World Forum for Harmonization of Vehicle Regulations

Working Party on Lighting and Light-Signalling

Report of the Working Party on Lighting and Light-Signalling on its sixty-sixth session

New Figure 4, amend to read:

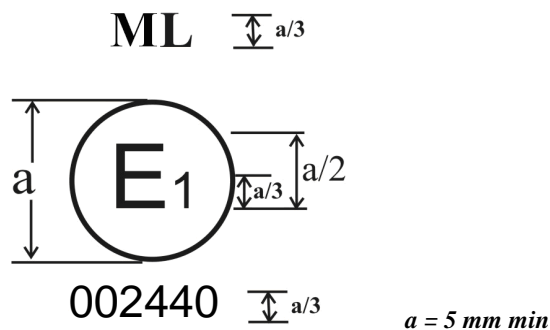
Delete the amendments to Figures 1 to 3

"Figure 4

Marking for a manoeuvring lamps

The device bearing the approval mark shown above is a manoeuvring lamp approved in Germany (E1) pursuant to Regulation No. 23 under approval number 2440.

The approval number indicates that the approval was granted in accordance with the requirements of Regulation No. 23 **in its original form.**

Model A

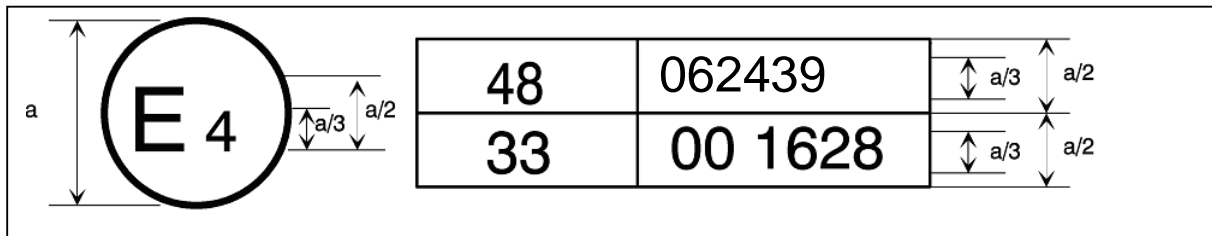
The above ... Regulation No. 48 as amended by the **06** series of amendments. The approval number indicates that the approval was granted in accordance with the requirements of Regulation No. 48 as amended by the **06** series of amendments.

Examples of approval marks

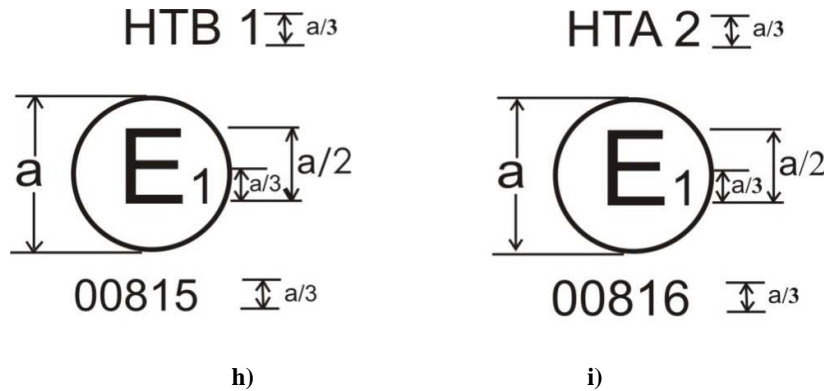
Annex 2, insert new examples of approval marks h) and i), to read:

- h) A half bar of a special warning lamp indicates that it has been approved in Germany (E1) under approval number 00815. The approval number shows that the approval was granted in accordance with the requirements of the Regulation in its original form and that it is a blue rotating or stationary flashing special warning lamp of class 1 (HTB 1).
- i) A half bar of a special warning lamp indicates that it has been approved in Germany (E1) under approval number 00816. The approval number shows that the approval was granted in accordance with the requirements of the Regulation in its original form and that it is a amber rotating or stationary flashing special warning lamp of class 2 (HTA 2)."
